## KRB STUDY REQUEST 4: Conveyance, Forebay, and Penstock Safety

## RESPONSE TO COMMENTS

## KRB SR-4: CONVEYANCE, FOREBAY, AND PENSTOCK SAFETY UPDATED STUDY PROPOSAL

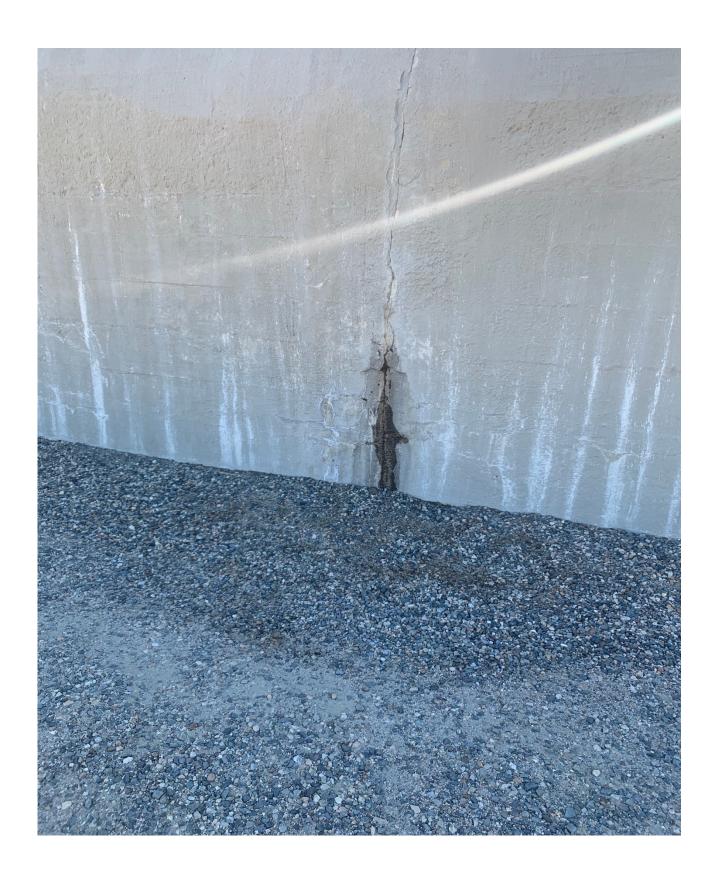
KRB has obtained <u>this brief video</u><sup>194</sup> of the project's pressurized siphon, which is significantly cracked and leaking. An image therefrom:
